Further to our communication of the 22th Sept 11, I have redrawn the West Elevation of this dormer at 64 Wroxham Way, Felpham as you have further requested. I have also included another revised floor plan so as you can see the reason as explained before as to why I was unable to draw two dormers, however you will see that I have also as requested reduced the length of the dormer again by approximately another 600mm.

PROPOSED DORMER ON EXISTING WEST ELEVATION

PROPOSED DORMER BEDROOMS

CLIENT, MR & MRS CHIDDLE
 64, WROXHAM WAY
 BOGNOR REGIS
 WEST SUSSEX
 PO22 8ES.

DRWG P4

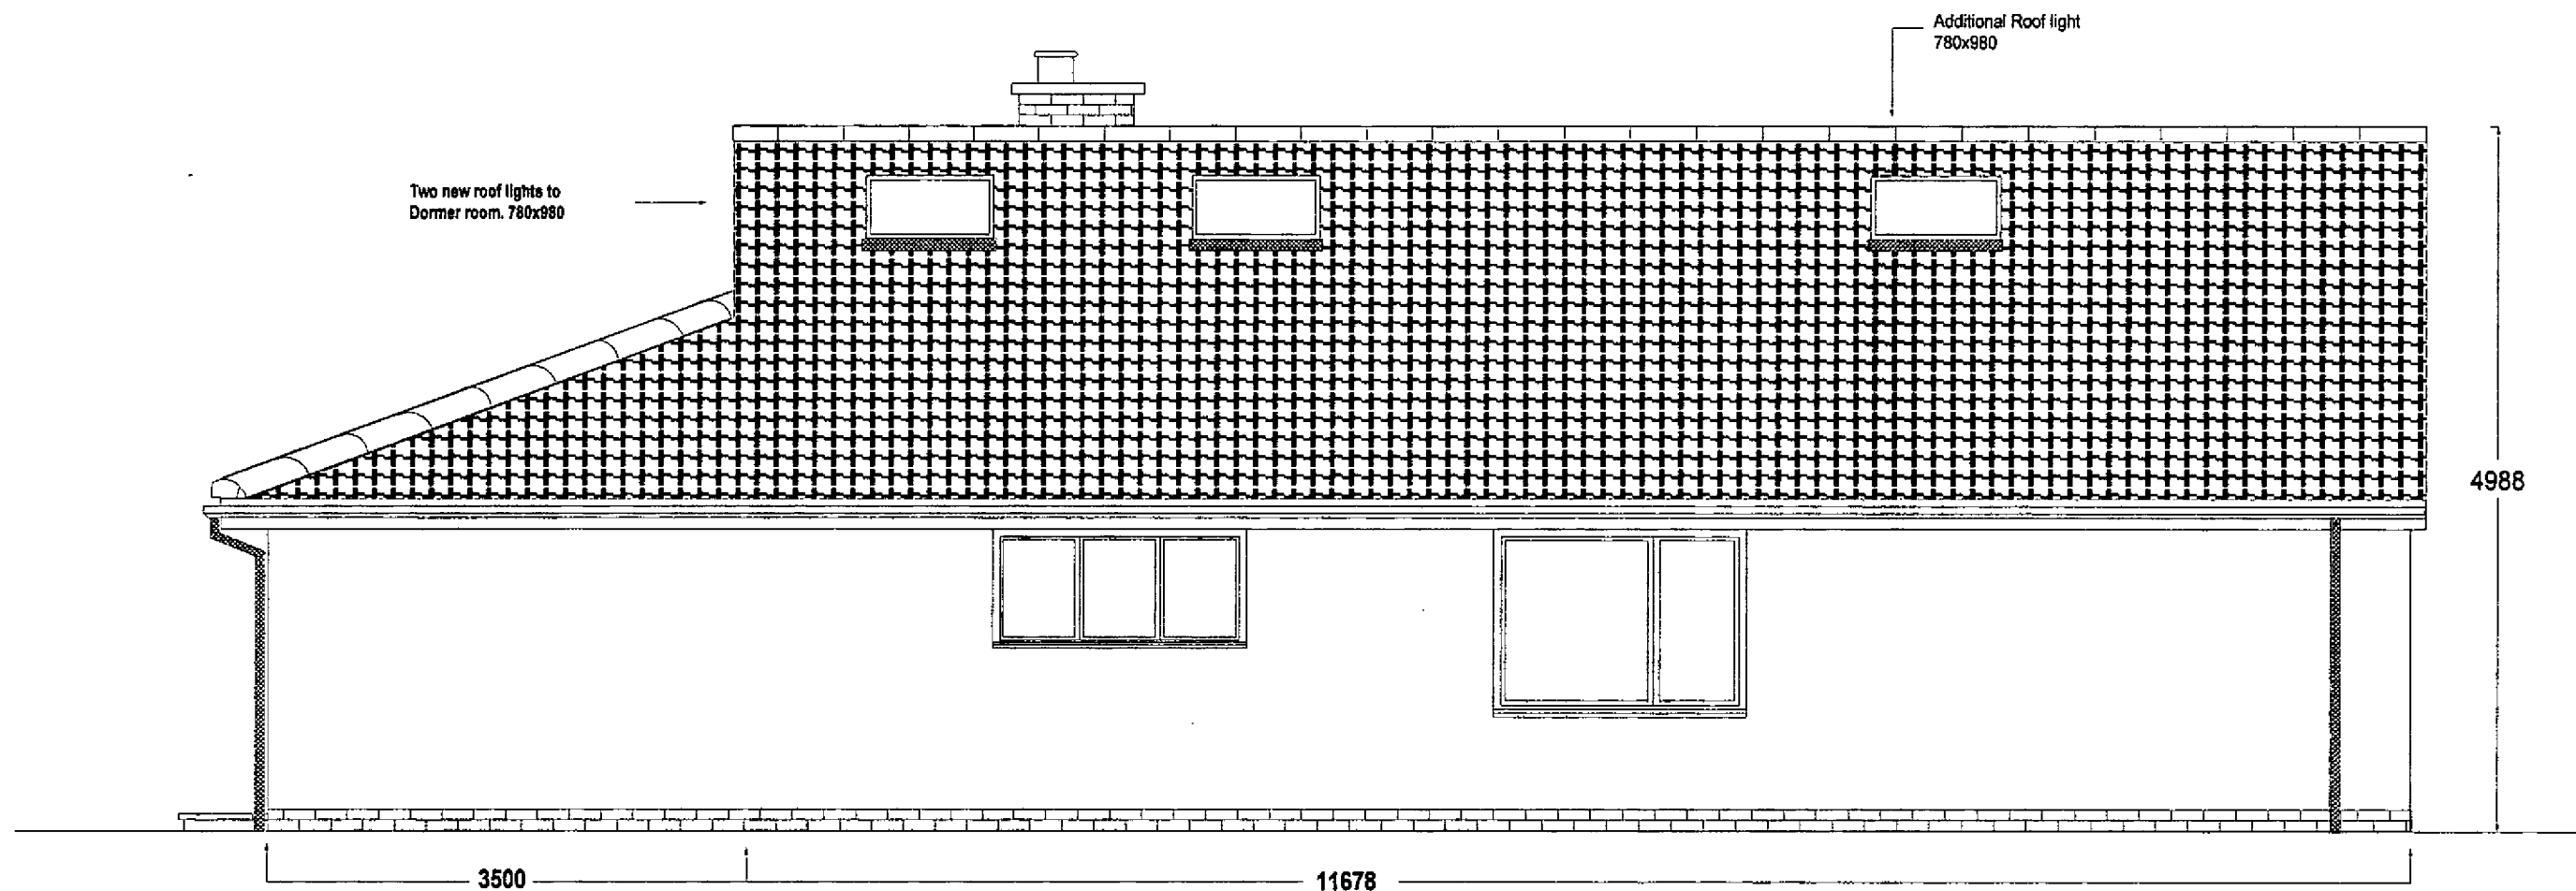
I have dropped the roof by 50mm, which is the most I can do, and I am counting on the structural engineer to find the answer to maintaining the inside storey height, probably a reinforced joist, eg. Two joists with a 10mm steel between them at whatever centre's. This way will enable us to reduce the floor level. I look forward to your comments.

Revised West elevation, dormer
 reduced in length, also windows
 of same size. The roof has been lowered by 50mm.

DRWG P3

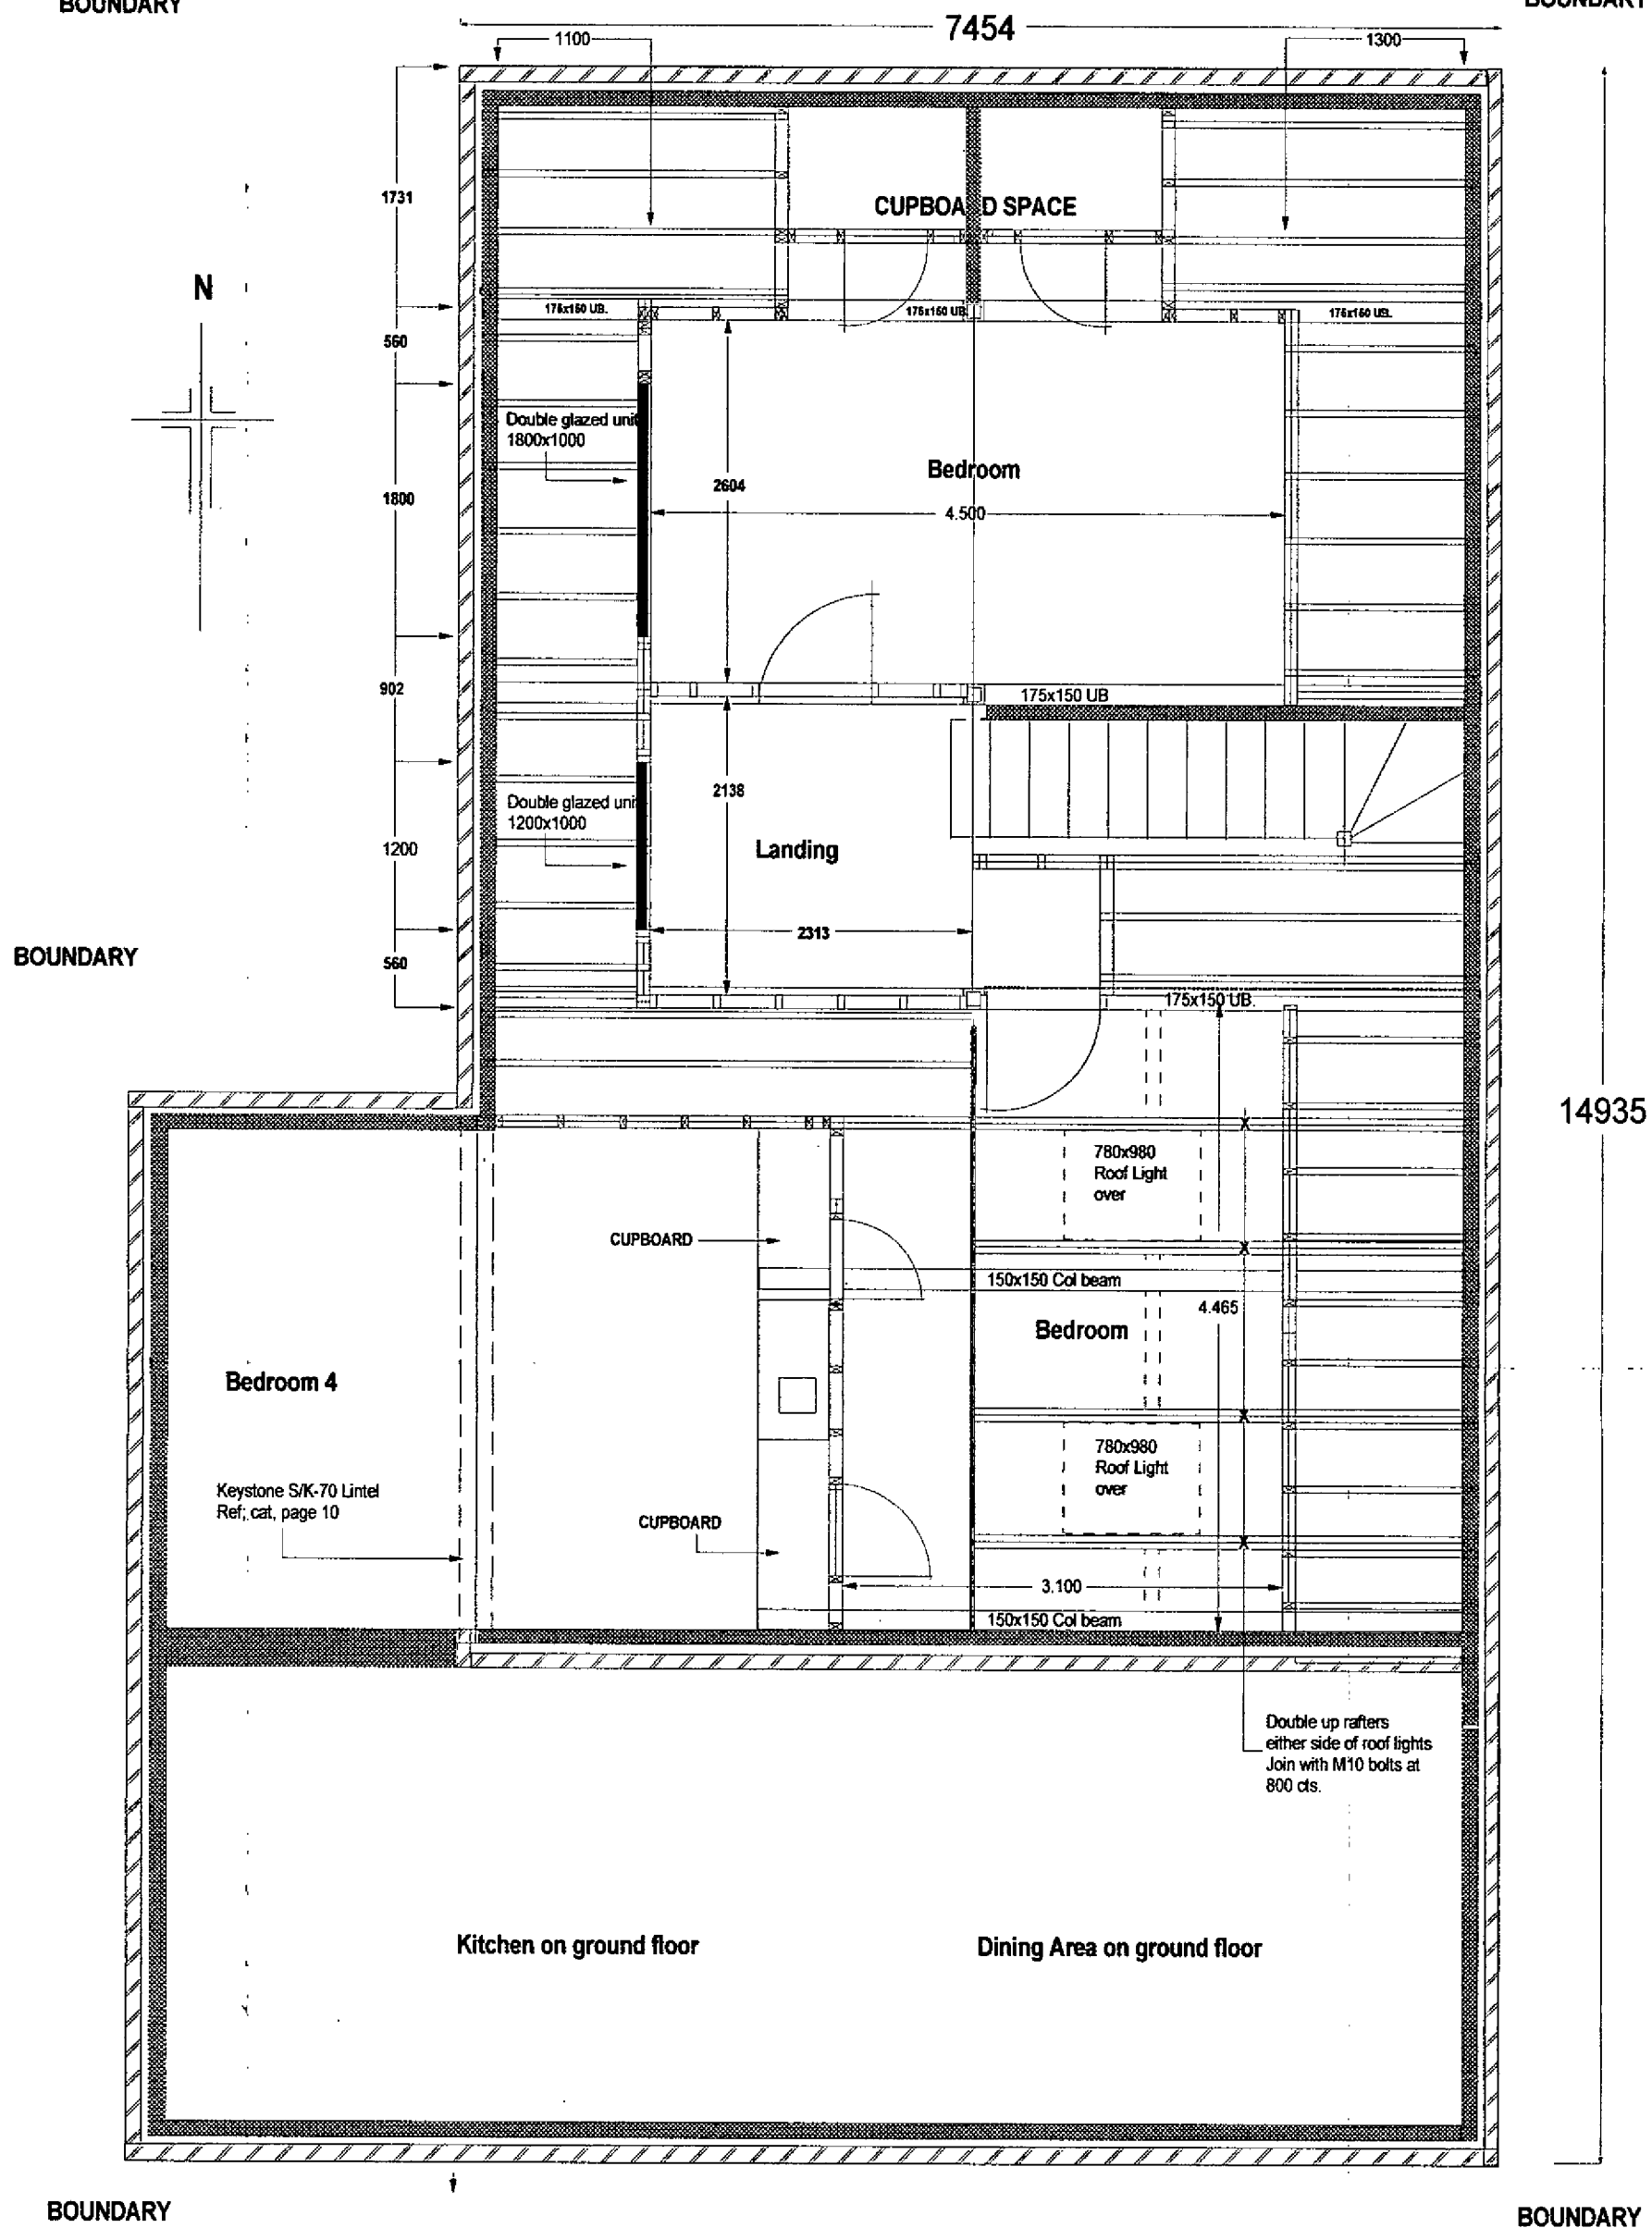
Revised East elevation, showing additional roof light to compensate for a smaller window on the West elevation.
